**Development of Columbarium at Sandy Ridge
Cemetery – Infrastructural Works at Man Kam To Road
and Lin Ma Hang Road**

Environmental Permit No. EP-534/2017/A

Layout Plan for the proposed footpath at Lin Ma Hang Road

Document No: CV/2017/02/R0023r3

Attachment A

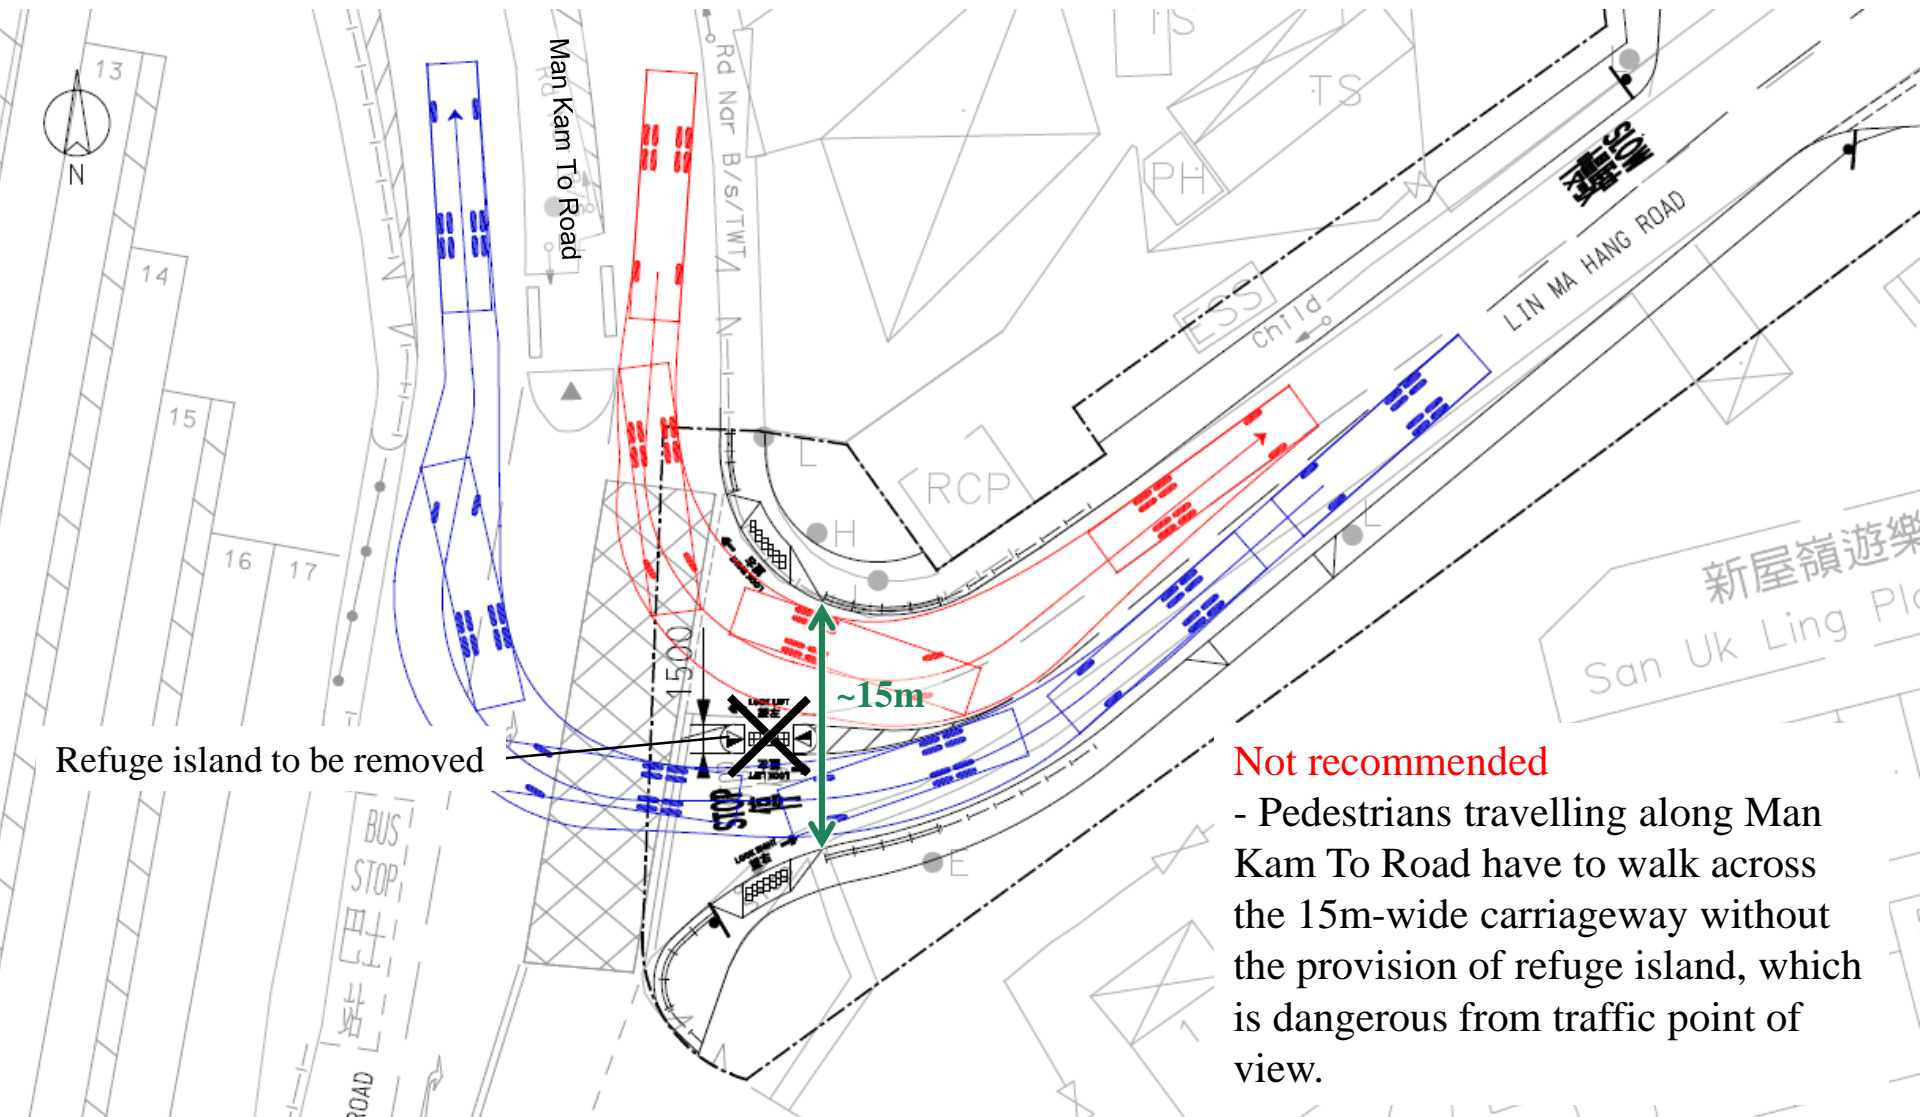
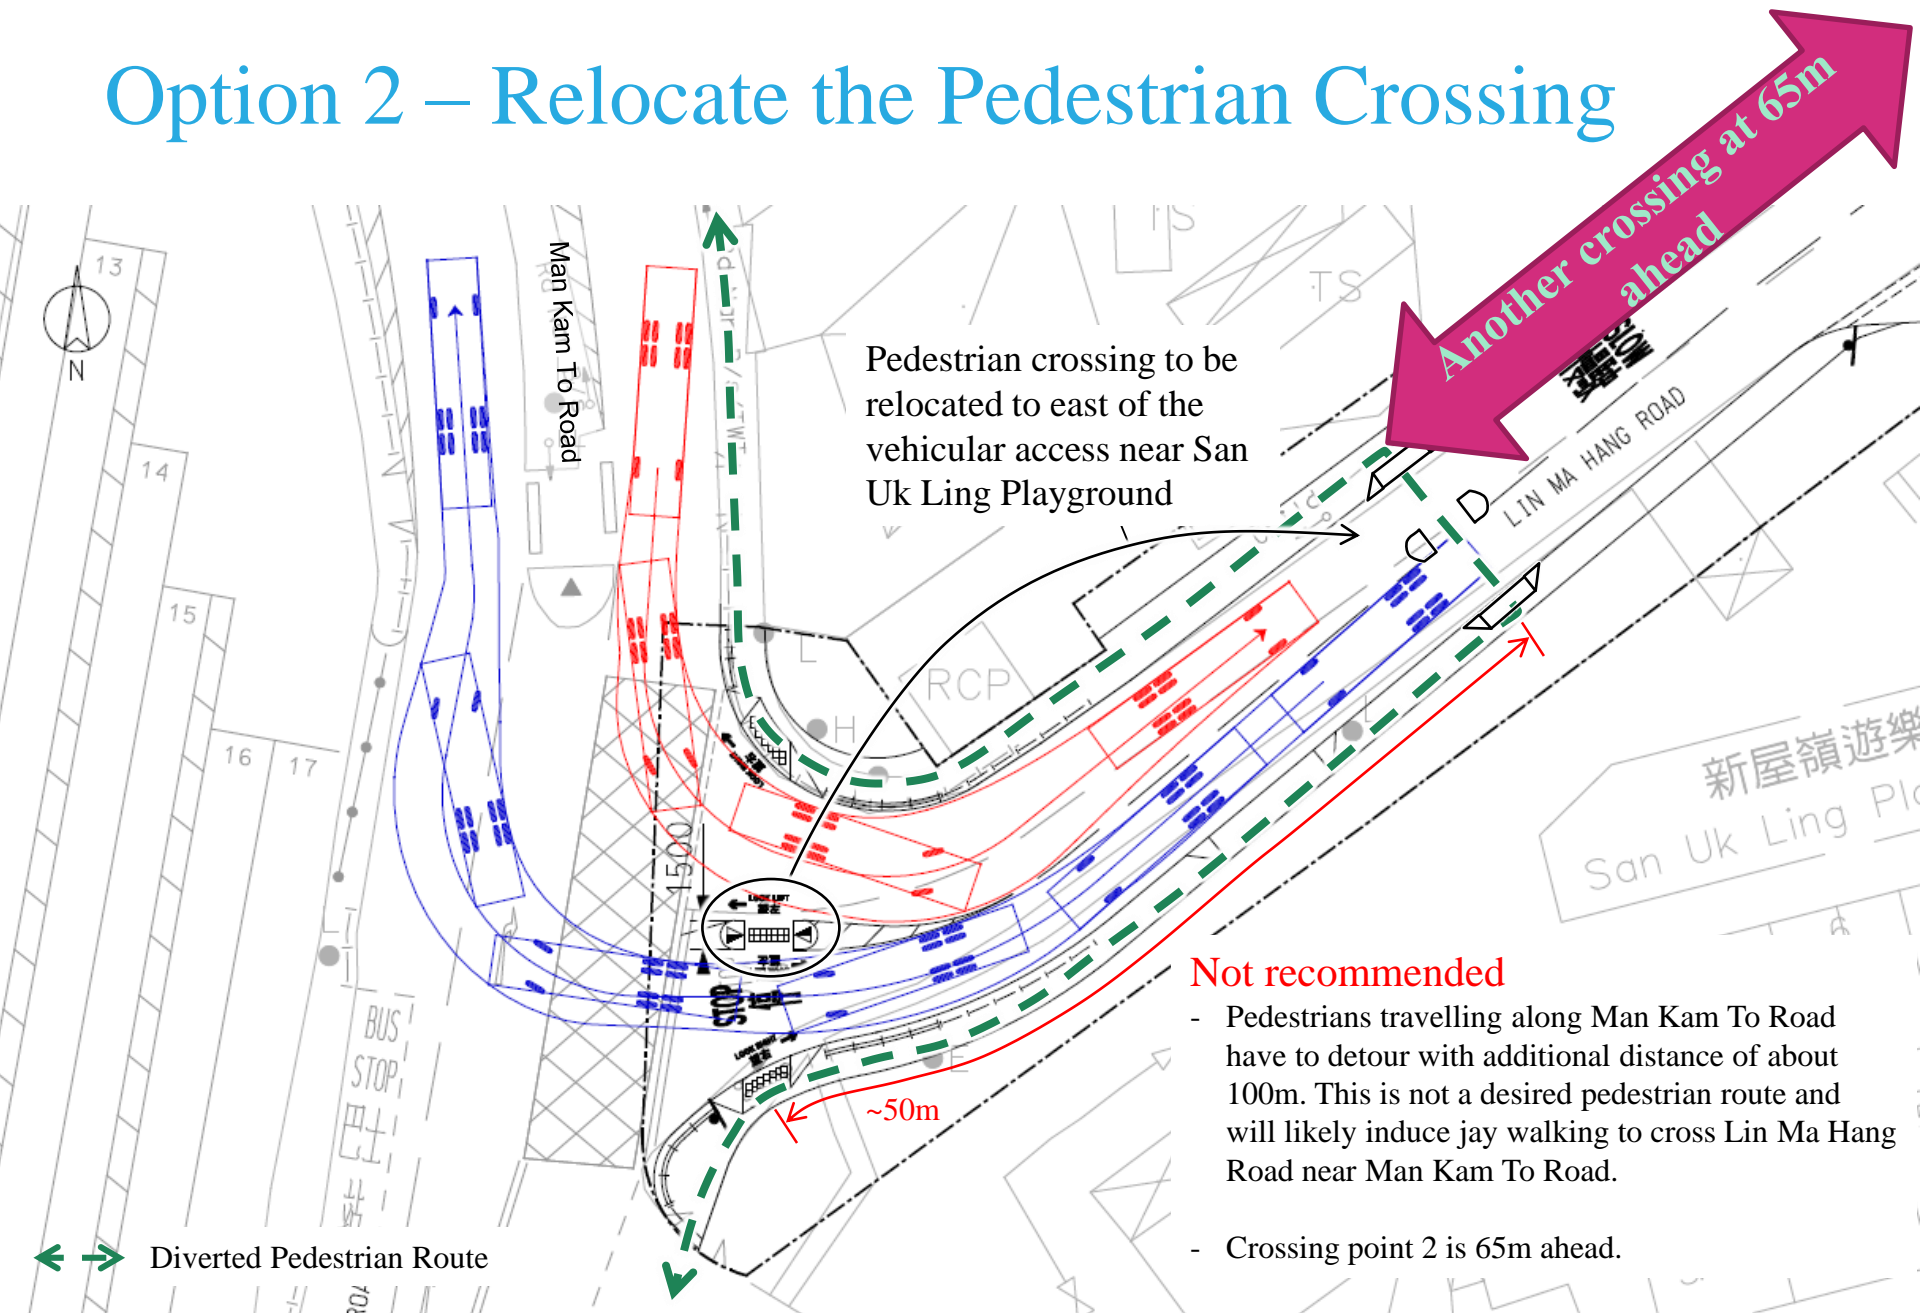
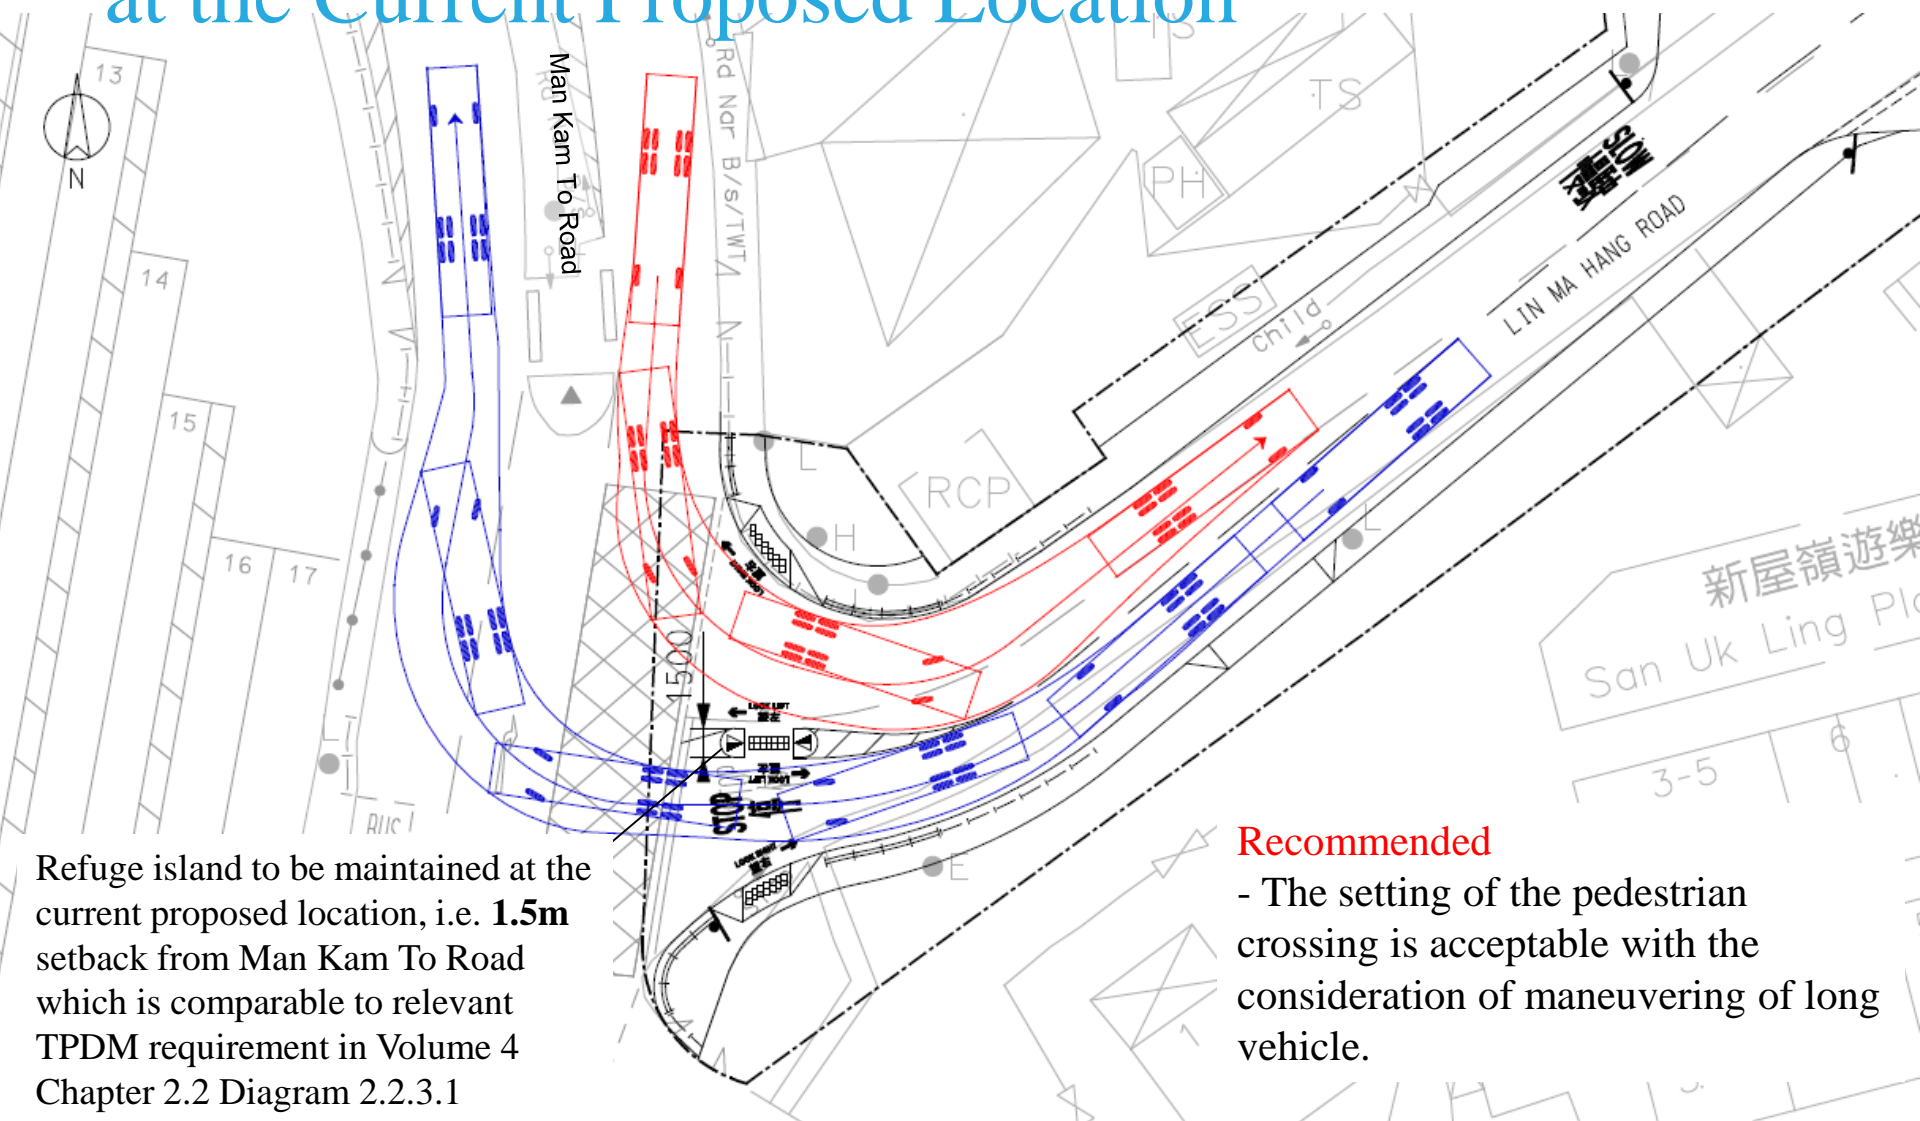
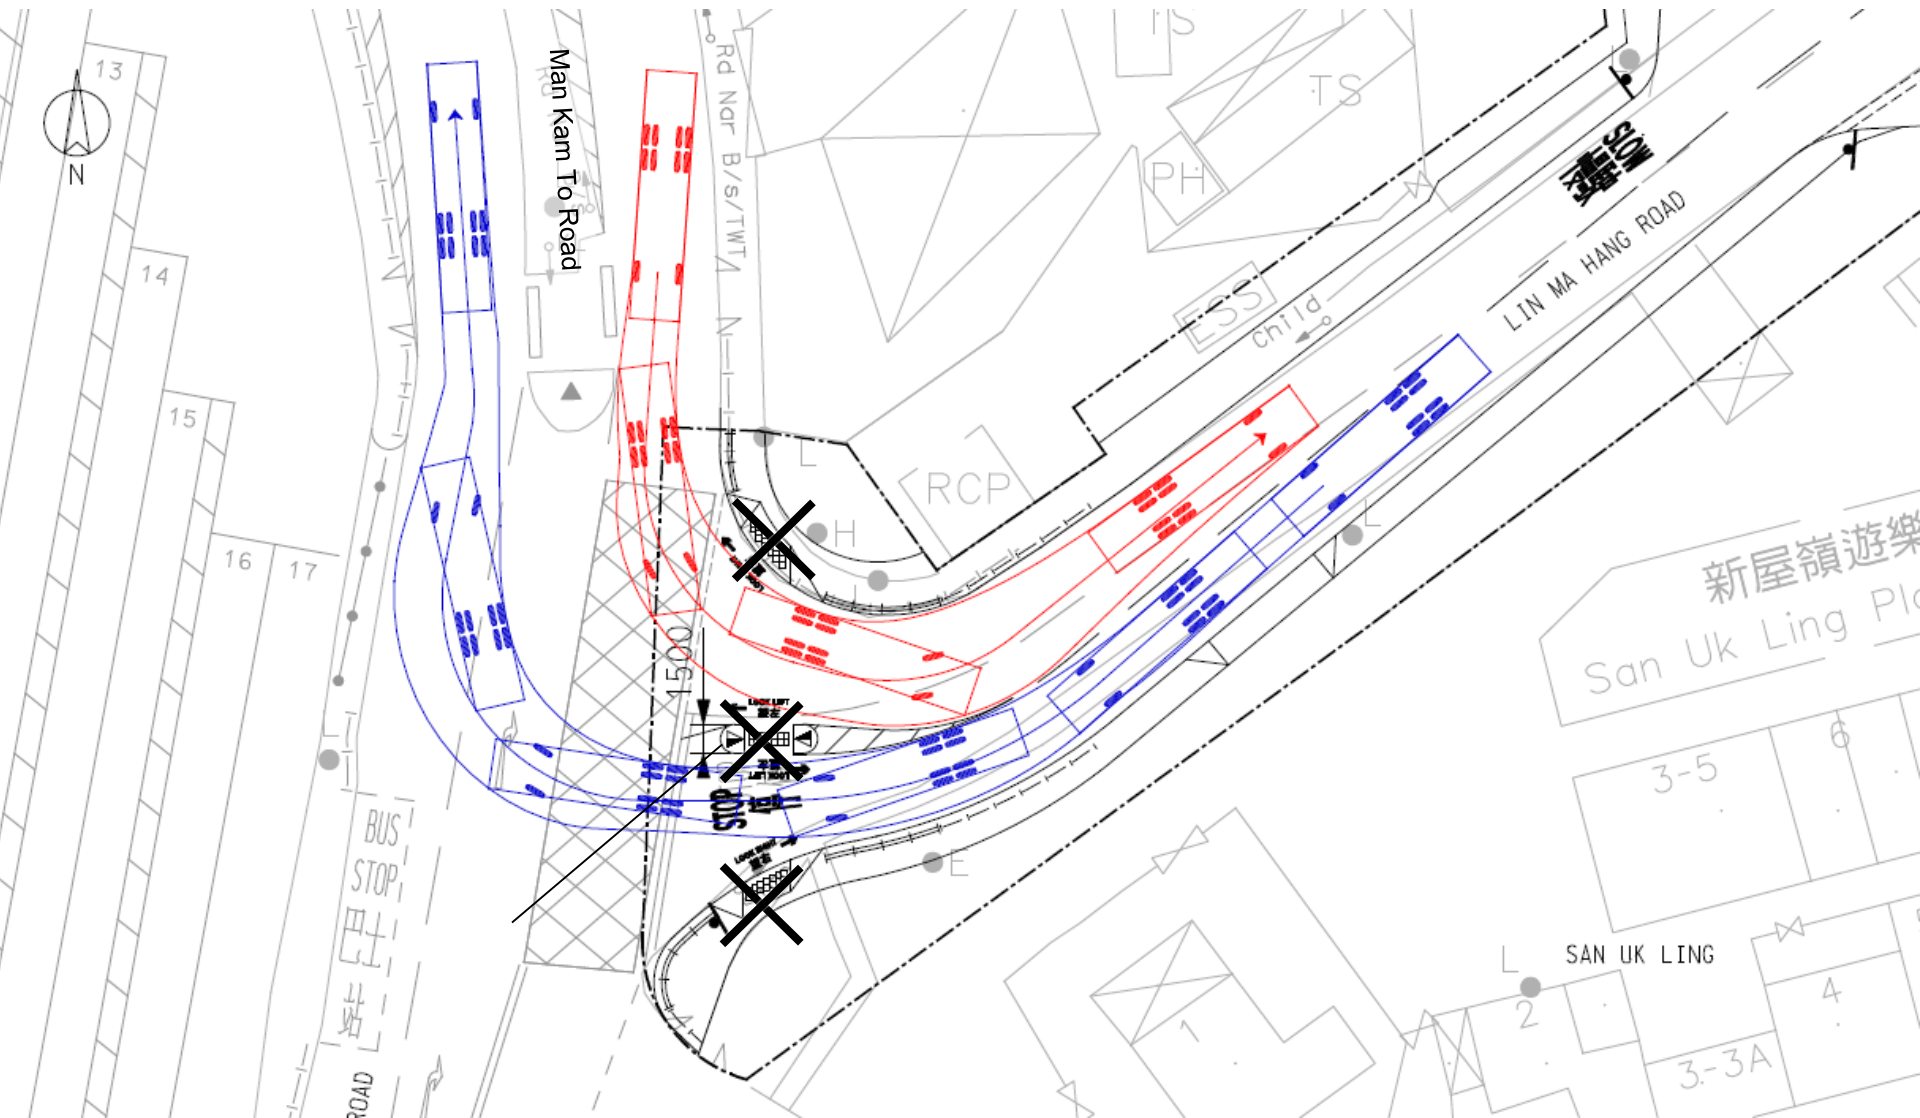
Comments received:	Responses:
<p><u>Drawing : 23144/C2/RD/3103A, Crossing Point 5, 6</u></p> <p>We have no further comment on the proposed road configuration at the crossing point with 3.8 wide traffic lanes on both sides of the 1.5m wide refuge island as marked up on your drawing.</p> <p><u>Drawing : 23144/C2/RD/3104A, Crossing Point 7</u></p> <p>Please provide refuge island.</p>	<p>Noted with thanks.</p> <p>At crossing no. 7, there is a registered slope no. 3NW-C/CR 456 (see Attachment B) immediately adjacent to Lin Ma Hang Road Northbound. It has been checked that the dropped kerbs and adjoining footpath arising from addition of refuge island in this crossing will encroach the footprint of the foregoing slope by 3-4m (see Attachment C), requiring detailed geotechnical assessment and filling works (if accepted by GEO and the maintenance department) for the widening. Taking into the foregoing consideration and that the peak hour pedestrian flow in the footpath section between the crossing no. 7 and the eastern Ping Yuen River is only around 1, it is considered that the arrangement of uncontrolled cautionary crossing under the conforming design is appropriate and addition of refuge island at crossing no. 7 is not recommended. It has also been checked that it is not recommended to shift the crossing no. 7 (with refuge island) either downstream / upstream of the current crossing point due to presence of other registered slopes and constraint of site boundary.</p>

Option 1 – Remove the Proposed Refuge Island

Recommended Option – Maintain the Refuge Island at the Current Proposed Location

Refuge island to be maintained at the current proposed location, i.e. **1.5m** setback from Man Kam To Road which is comparable to relevant TPDM requirement in Volume 4 Chapter 2.2 Diagram 2.2.3.1

Alternative – Cancel the pedestrian crossing
